USTA CAMPUS EXPANSION

SUMMARY

<p>Owner Rob Holmes Lake Nona Land Company, LLC</p> <p>Applicant Nathan Butler HKS</p> <p>Project Planner Colandra Jones, AICP</p> <p>Updated: January 2, 2026</p>	<p>Property Location: The subject property is located west of Performance Drive and USTA Boulevard, and south of Lake Nona Boulevard, and addressed as 10000 USTA Boulevard (PID: 14-24-30-4964-01-000; 14-24-30-4965-04-001 & a portion of 14-24-30-4965-04-000) (±8.96 acres, District 1).</p> <p>Applicant's Request:</p> <ol style="list-style-type: none"> Specific Parcel Master Plan (SPMP) amendment for USTA Campus expansion reconfiguring the southern portion of the campus by removing 6 hard surface courts, adding an 80,000 square foot indoor tennis facility, 8 new hard surface courts, with surface and grass overflow parking spaces. 	<ol style="list-style-type: none"> Major Plat to reconfigure portions of the expansion area. <p>Staff's Recommendation: Approval of the request, subject to the conditions in this report.</p>

Site Plan with Proposed Indoor Tennis Courts

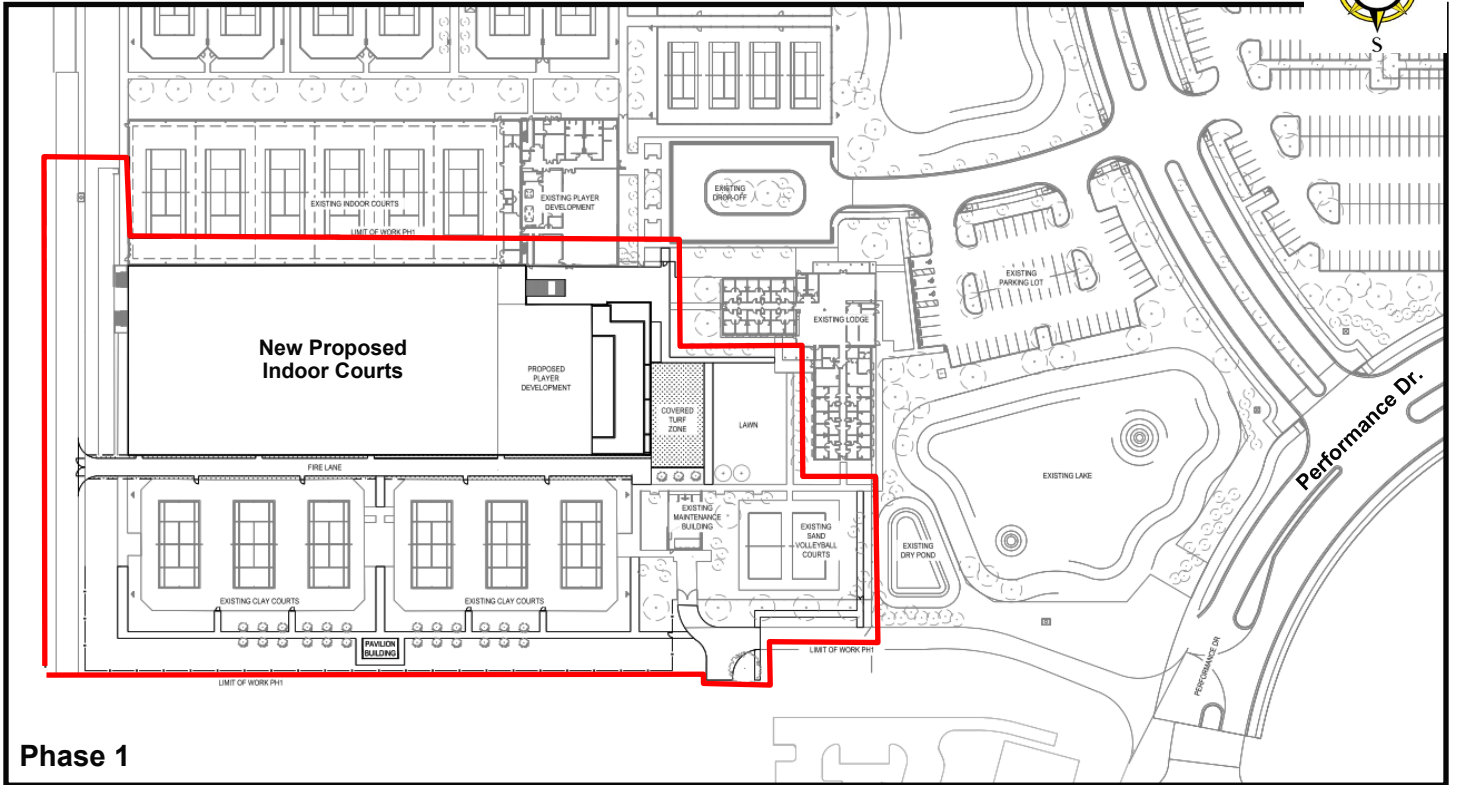
- g. To promote safe operational movement within the overflow parking area, the applicant shall specify how the area will be managed. If the area will be served-parked and will utilize standard grass parking markings, the applicant shall comply with the Land Development Code with respect to drive aisles and parking dimensions.

- h. At the time of permitting, the applicant shall revise the overall site plan sheets to eliminate any proposed grass parking in the southeast (SE) corner, as this area will contain a T-intersection and the placement of an R-1 traffic control device.

Site Plan with Fire Components

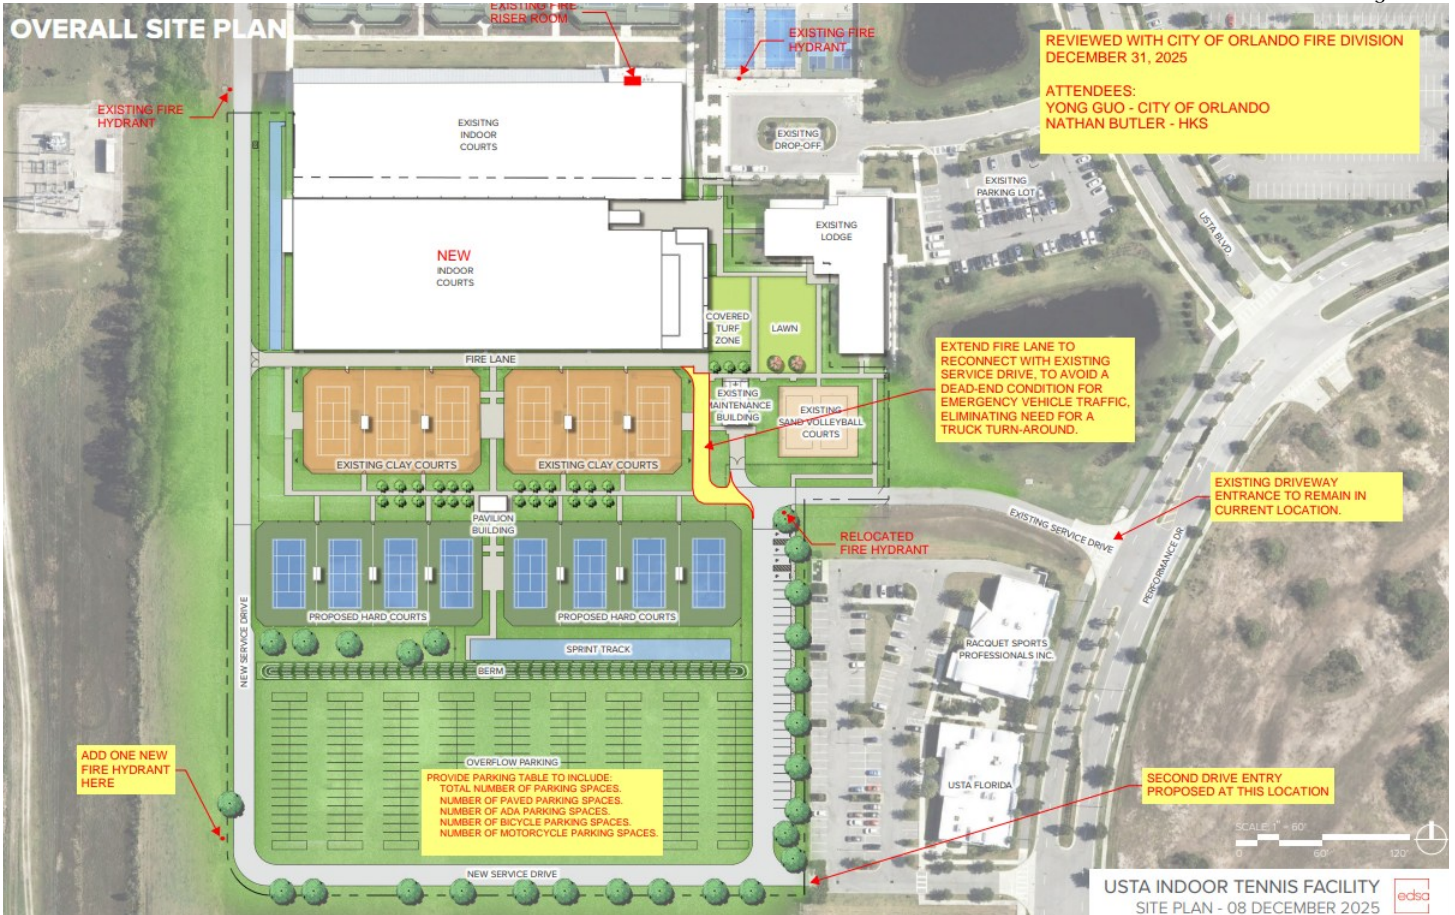
South of the proposed new indoor courts, the site plan depicts a fire lane. Transportation and Fire had concerns that the fire lane dead-end on the east side with no turn-around for the fire trucks. After review with the Fire reviewer, the applicant proposes to extend the fire lane to connect with the existing service drive to remedy this concern. The proposed connection and addition of a new fire hydrant on the west side of the site near the new overflow parking is depicted on page 10 of this staff report. The dimensioned site plan would need to be revised to reflect these changes.

- e. At the time of permitting, the applicant shall provide dimensions for the newly proposed extension of the fire lane located south of the new indoor courts building. In addition, the applicant shall clearly indicate the elevations for the sidewalk connection. If gate access is proposed, the applicant must coordinate with the Fire Department to identify and approve the access mechanism.

Architectural Elevations for Indoor Courts

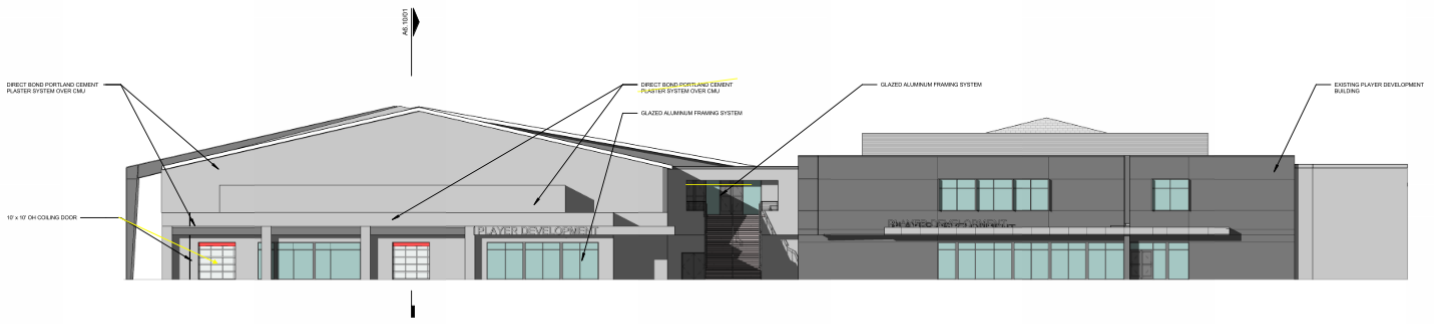
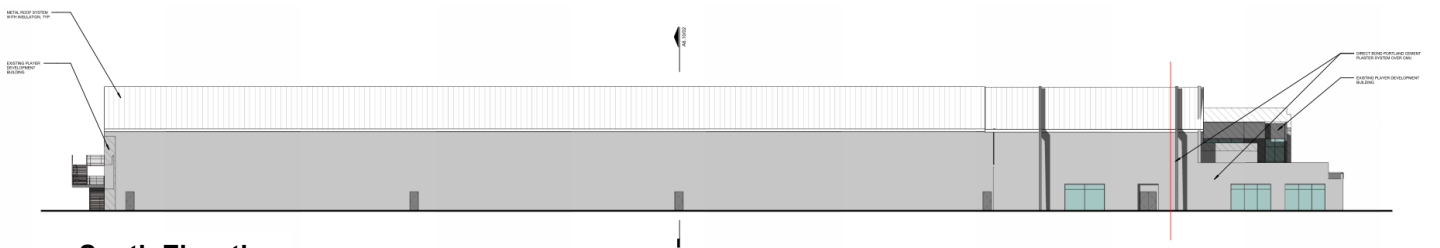
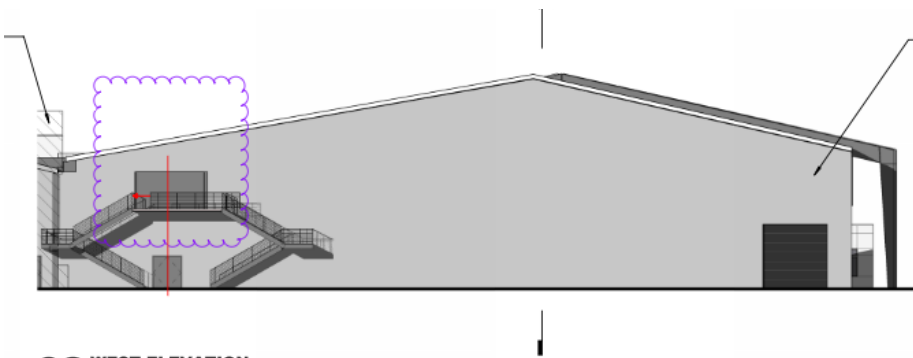
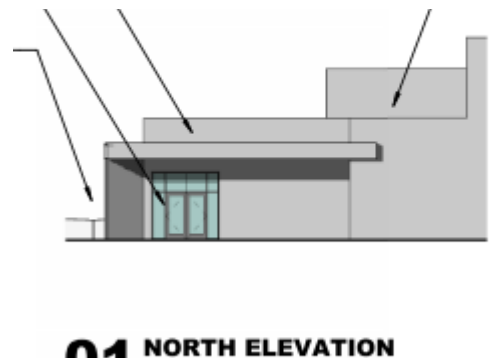
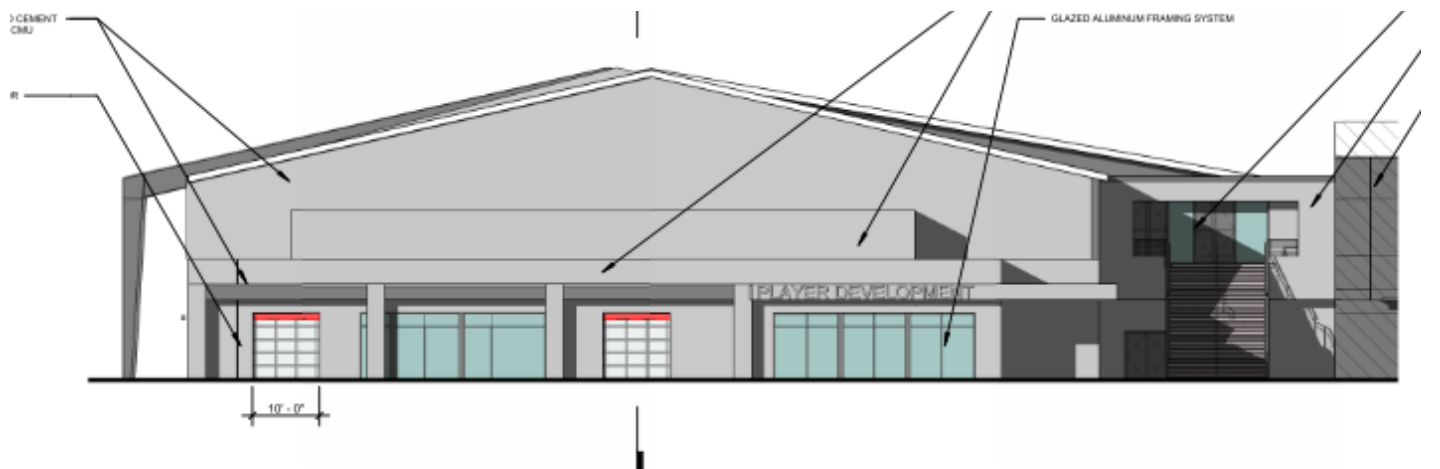
4. At the time of Permitting, the elevations will need to have material callouts to distinguish what materials are being used.
5. Every main entrance/breezeway of the building's facade that have entrances are required to have a special emphasis appropriate to the architectural style of the building.

6. Substantial sheltering element such as a porch, awning, arcade, or portico as well as canopies and differentiation in materials should be used to clearly articulate and highlight these entrances. This will need to be shown on the elevations at the time of Permitting.

7. A minimum 15% transparency is required on all facades facing a public street, private street, or courtyard, on each story below the roofline. A minimum 10% transparency is required on all interior side facades on each story below the roof line. From the provide elevations, this requirement is being met. At the time of Appearance Review and building permits, this must remain consistent.

Subdivision Plat

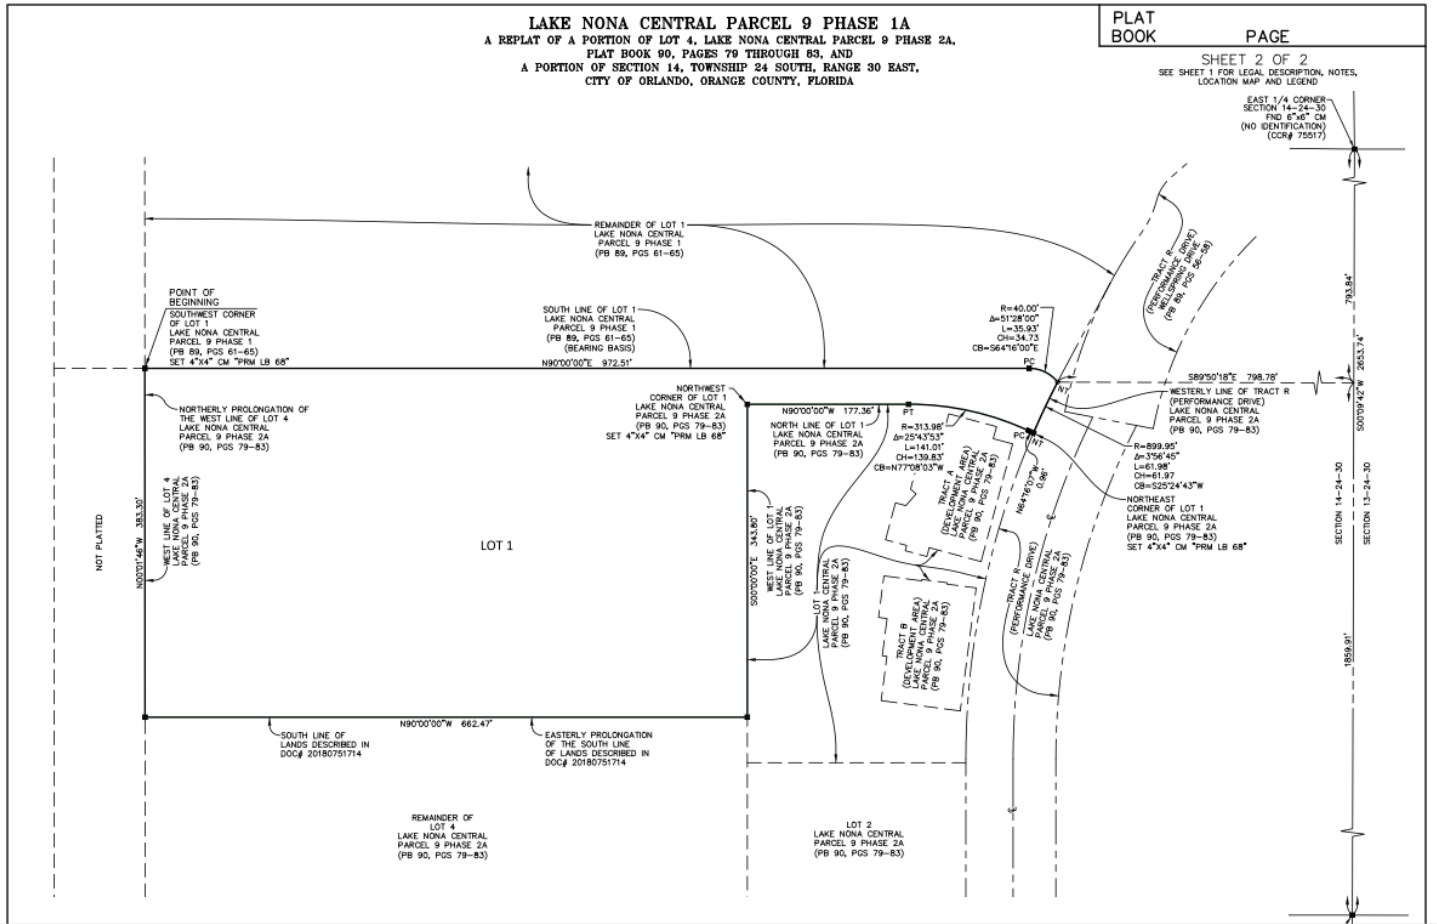
2. Administrative
 - a. The applicant is required to submit a revised draft plat document in which the boundaries are clearly displayed in accordance with the site plan included in the planning application package. At a minimum, the applicant should incorporate the appropriate legal cross-access easements. This should include, but is not limited to: (a) The second southern access point, through the property located at 11965, should be identified as a cross-access; (b) Legal cross-access easements for utilities, fire services, and general maintenance to allow connection from the existing USTA parcel to the newly proposed Lot 1; and, (c) Legal cross-access easement between the northern lot and the newly proposed Lot 1, as there can be only one ROW access to Performance Drive.

- c. When submitting the revised plat, the applicant should clearly indicate to staff if there is any infrastructure between the two lots, the existing campus lot and the proposed new boundaries for Lot 1.

- d. At the time of the permitting submission, the applicant should clarify Note #4 under General Notes on the Lake Nona Central Parcel 9, Phase 1A sheet, which references easements. The plat currently does not show any proposed or existing easements. The applicant must clarify whether any new easements are proposed or if any existing easements apply.
